ALTICO SERVICE BULLETIN

#ASB 060700

SUBJECT: STIFFENER IN TOP FLAP OF DOLPHIN MAIN CONTAINER

FIG. 1

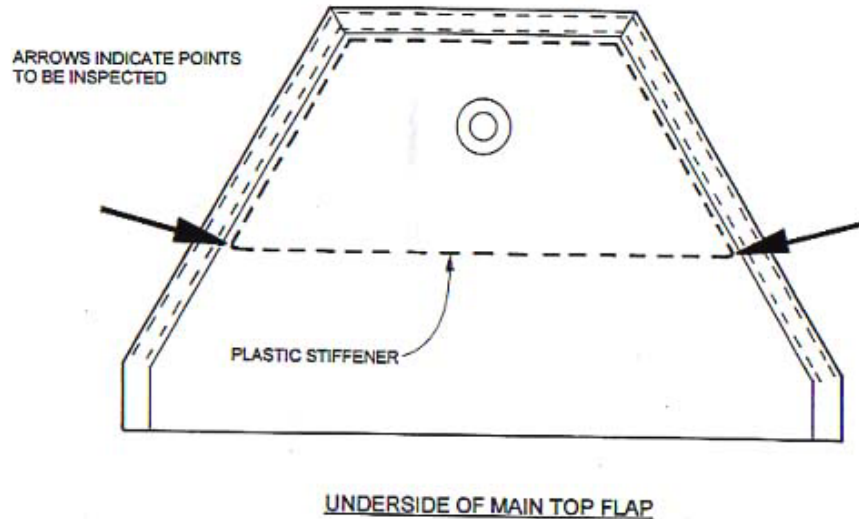
- 1) Inspect underside of main top flap at points indicated in FIG. 1. If a corner of the plastic stiffener is exposed by wear, proceed to step 2.

FIG. 2

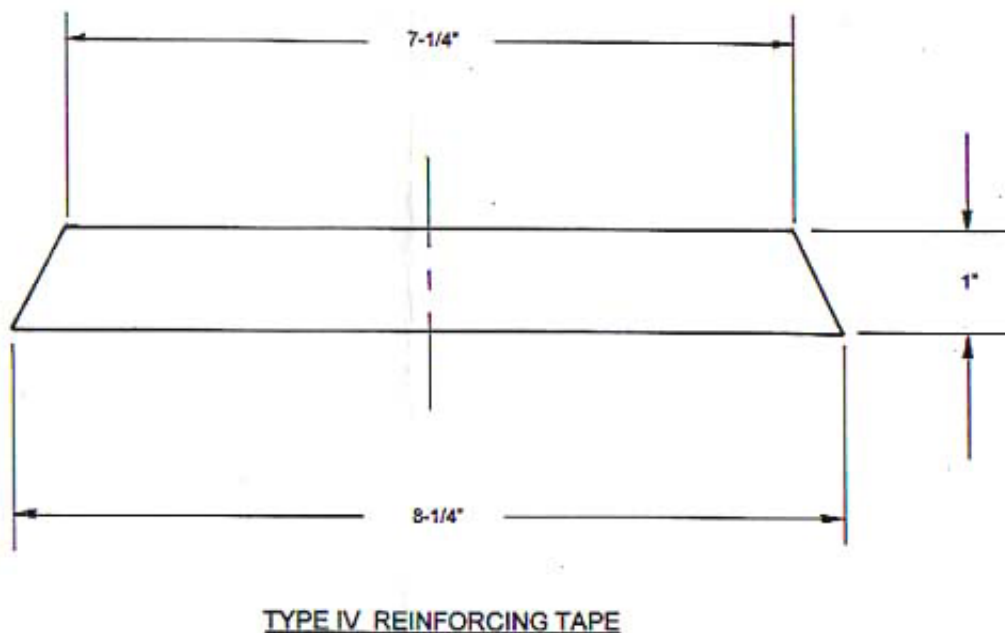
- 2) With a hot knife, cut a piece of 1" Type IV tape as shown in FIG. 2.

FIG. 3

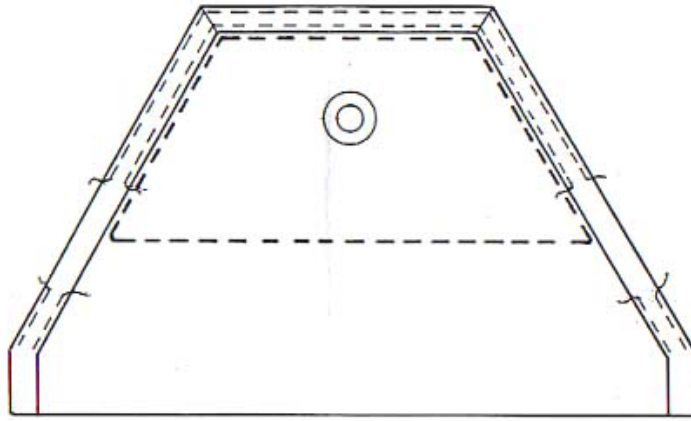
- 3) Remove the stitches from a 1-3/4" (approx.) section of binding tape along each side of the main top flap. The section of removed stitches must be centered on the edge of the stiffener as shown in FIG. 3. This is done so that the ends of the reinforcing tape may be installed under the binding tape.

FIG. 4

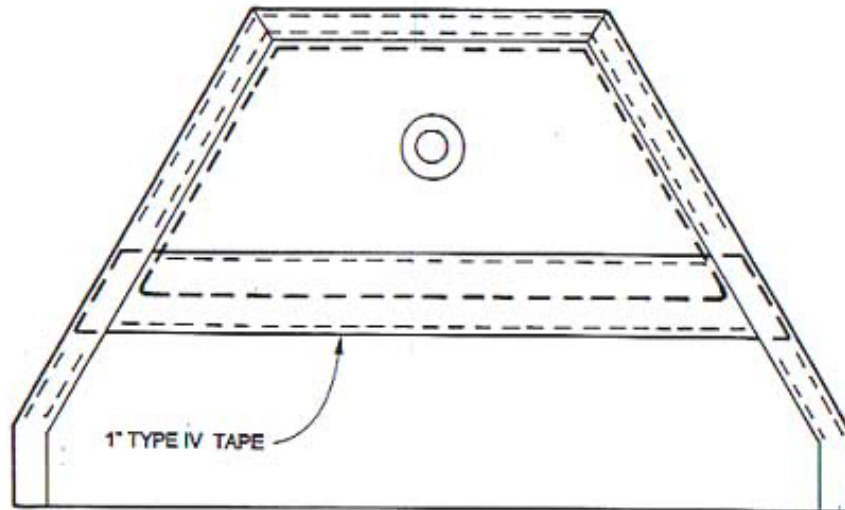
4) Center the prepared piece of 1" Type IV tape over the edge of the stiffener and stitch as shown in FIG. 4.
